Coffs Harbour Bypass

Submissions Report
Volume 2. Chapters 4-8

Response to community submissions

Coffs Harbour Bypass
 Construction access routes
 Figure 4.5-1

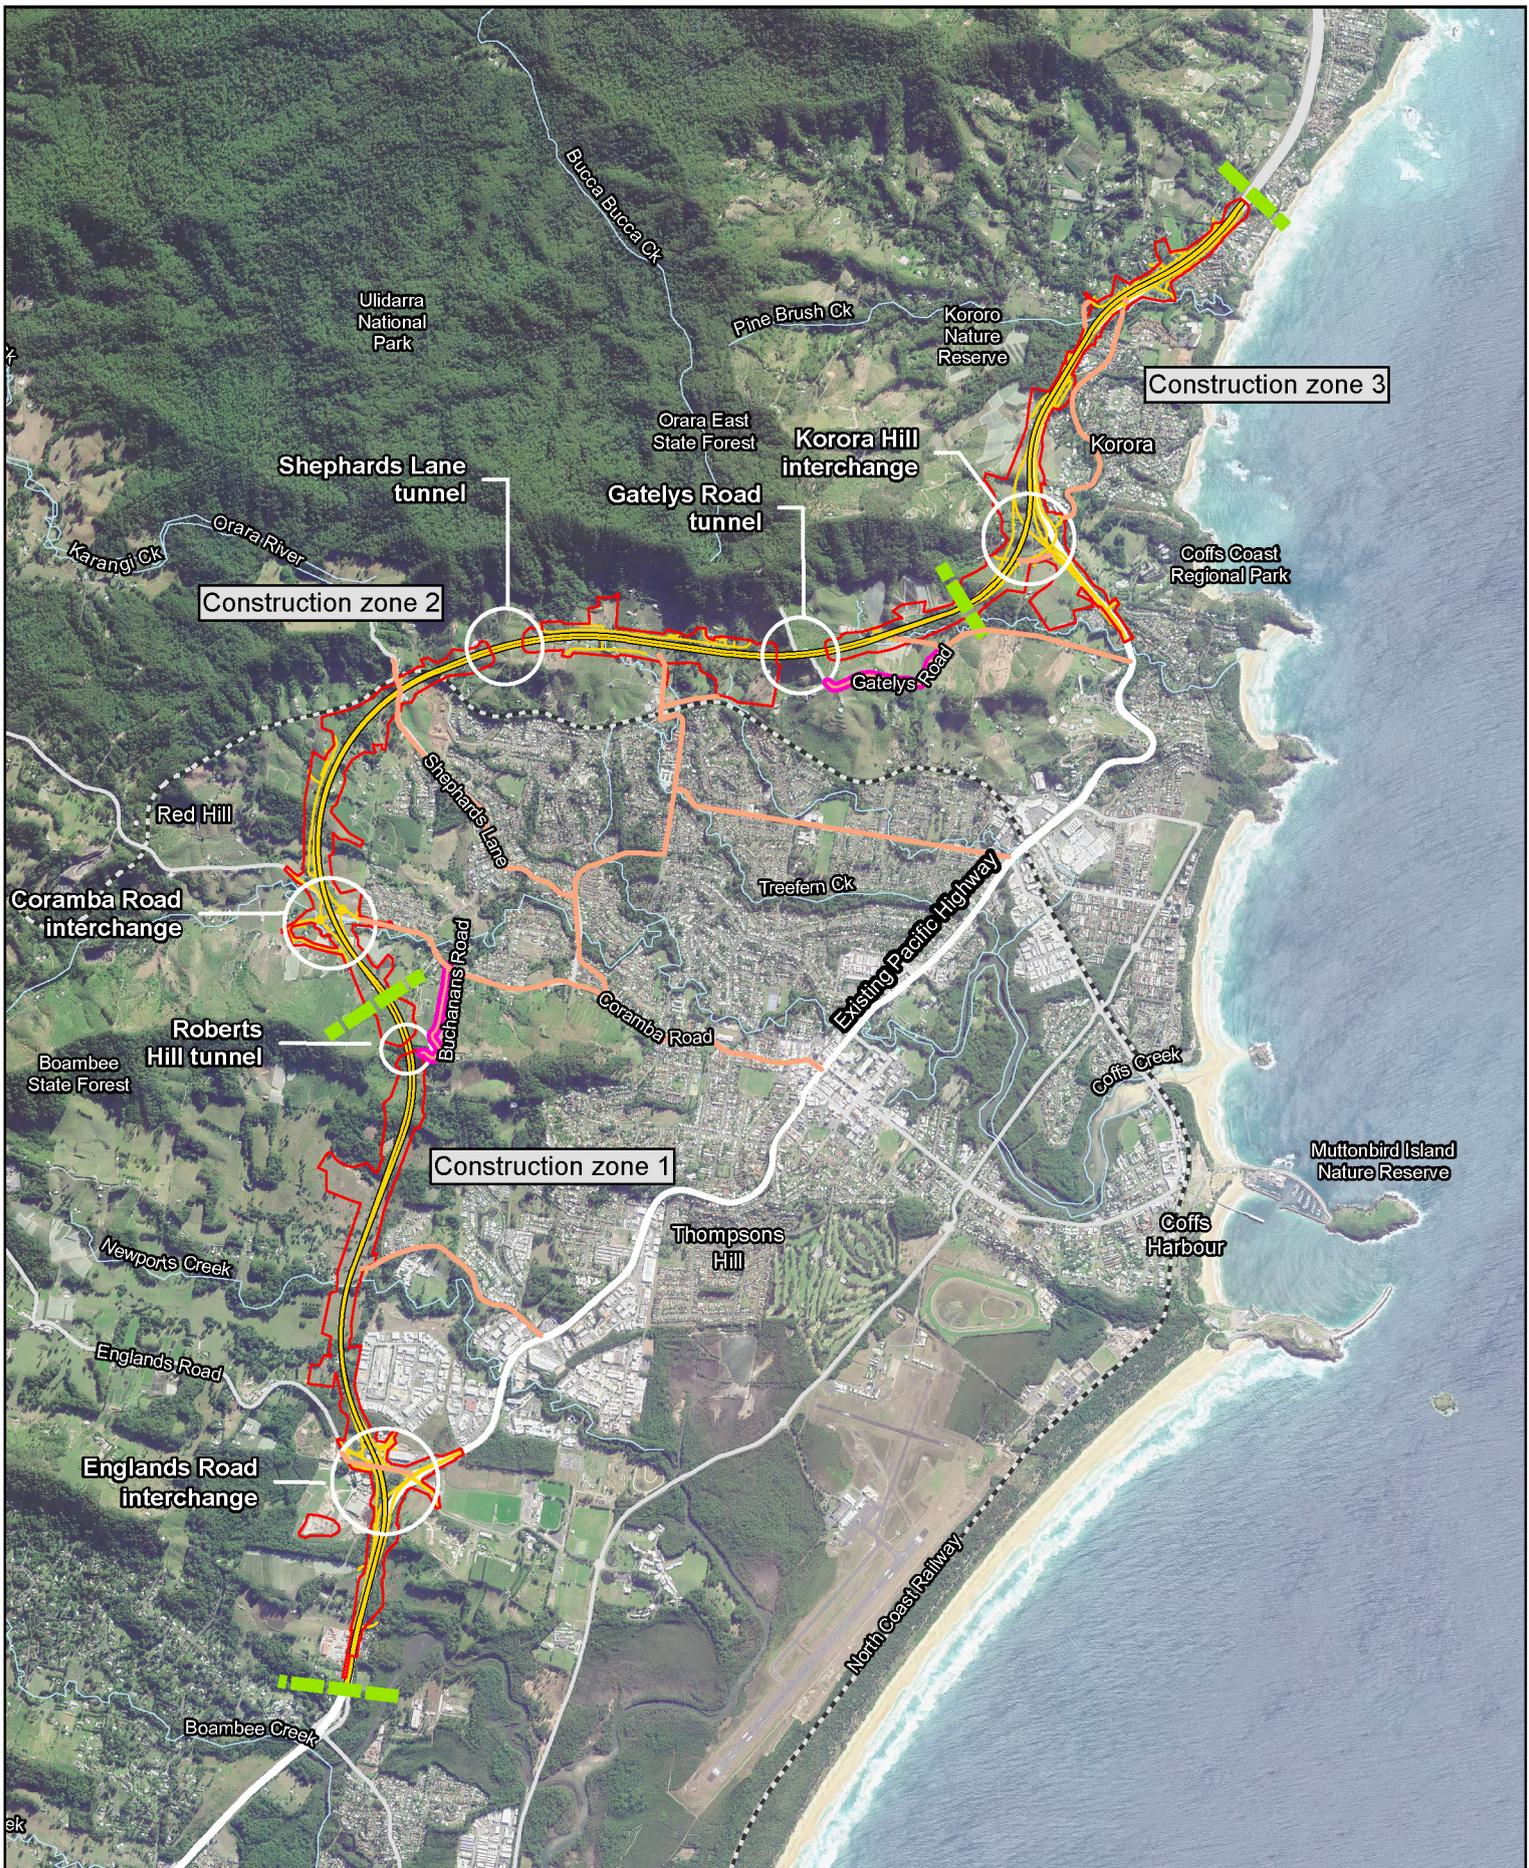
- Staging methods and routes for construction access and transportation of equipment, personnel and construction supplies, have not been provided.

Potential construction staging methods and construction access routes have been considered in various sections of the EIS. Staged delivery of the project is considered in Section 6.2.2 of the EIS. Construction traffic staging is discussed and assessed in Section 8.3.5 of the EIS, and construction access routes are discussed and assessed in Section 6.8.1 and Section 8.3.3 of the EIS respectively.

Following exhibition of the EIS, further consideration was given to construction access requirements for the project. Two new construction access roads were identified for the project, Gatelys Road and Buchanans Road. The purpose of these two new construction access roads are described in Chapter 3, Construction updates of the Amendment Report and the new construction accesses are assessed in Section 5.2, Traffic and transport, Section 5.3, Noise and vibration and Section 5.8, Socio-economic of the Amendment Report. **Figure 4.5-1** shows the updated construction access routes.
